Project	IEEE 802.16 Broadband Wireless Access Working Group < http://ieee802.org/16 >		
Title	Proposed Text For Legacy Support Frame Structure		
Date Submitted	2008-03-17		
Source(s)	Mark Cudak Motorola	Voice: E-mail:	Mark.Cudak@motorola.com *< http://standards.ieee.org/faqs/affiliationFAQ.html >
Re:	Response to frame structure rapporteurs call for comments C802.16m-008/118r1		
Abstract	In rapporteur contribution IEEE 802.16m-008/118r1 all legacy support proposal 1, 2 and 3 describe a fixed offset between IEEE 802.16m and IEEE 802.16e frames. This offset is unnecessary. This offset construct is misleading and may impede the resource sharing between legacy and 16m systems.		
Purpose	Discussion and approval		
Notice	<i>This document does not represent the agreed views of the IEEE 802.16 Working Group or any of its subgroups. It represents only the views of the participants listed in the "Source(s)" field above. It is offered as a basis for discussion. It is not binding on the contributor(s), who reserve(s) the right to add, amend or withdraw material contained herein.</i>

Proposed Text For Legacy Support Frame Structure

Mark Cudak
Motorola

Figure 11.4-3: Relative position of the new and legacy radio frames (example TDD duplex scheme) -> proposal-4

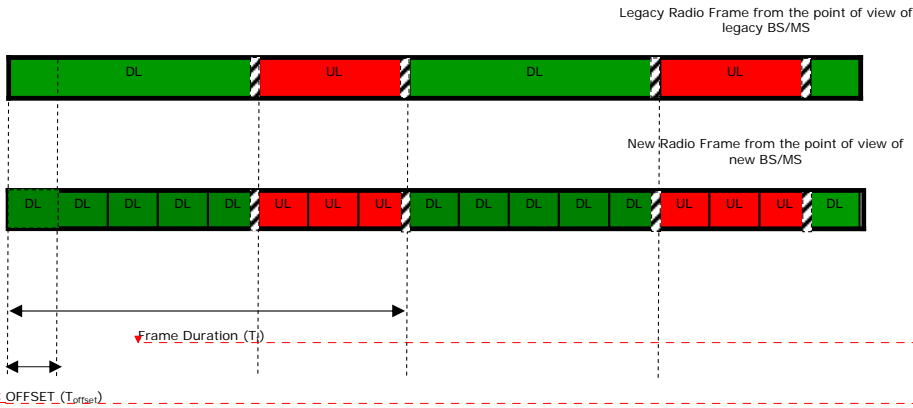
In rapporteur contribution IEEE 802.16m-008/118r1 all legacy support proposal 1, 2 and 3 describe a fixed offset between IEEE 802.16m and IEEE 802.16e frames. This offset is unnecessary. The offset is only a clever way to explain the relative position of synchronization channel within the 16m frame. The resulting description is confusing as a typical 16m frame may have two disjoint downlink intervals in one frame. Moreover, this offset may impede the dynamic sharing of resources between 16e and 16m. Ideally, the symbols within a frame should be dynamically shared between 16m and 16e. Subframes should be allocated to 16e or 16m on a frame-by-frame basis. However, the offset implies that the proportion of frame allocated to 16e preventing the dynamic repartitioning of resources.

A simpler model of legacy support would describe the 16m and 16e frame as being aligned in time having overlapping downlink and uplink intervals. The 16m synchronization sequence may be offset from the beginning of the frame providing a configuration that is functionally equivalent to the original text while allowing for the reallocation of resources from 16m to 16e and vice-versa. Moreover, one may consider using a fractional offset for the 16m features to allow greater efficiency in legacy support.

The legacy and 16m frames are aligned in time for the purpose of coexistence and the dynamic sharing of resources between legacy and new systems. 16m features such as new synchronization channel (preamble), broadcast channel (system configuration information), and control channels, as shown in Figure 11.4-3 (proposal-4) may be offset from the beginning of the 16m frame to prevent overlap of the 16e and 16m preambles. The synchronization offset may be an integer or fractional number of sub-frames.

- Deleted: new
- Deleted: are offset by a fixed number of sub-frames to allow accommodation of new features
- Deleted: 1
- Deleted: FRAME_OFFSET
- Deleted: (default value is two sub-frames)

- Deleted: Legacy
- Deleted: FRAME
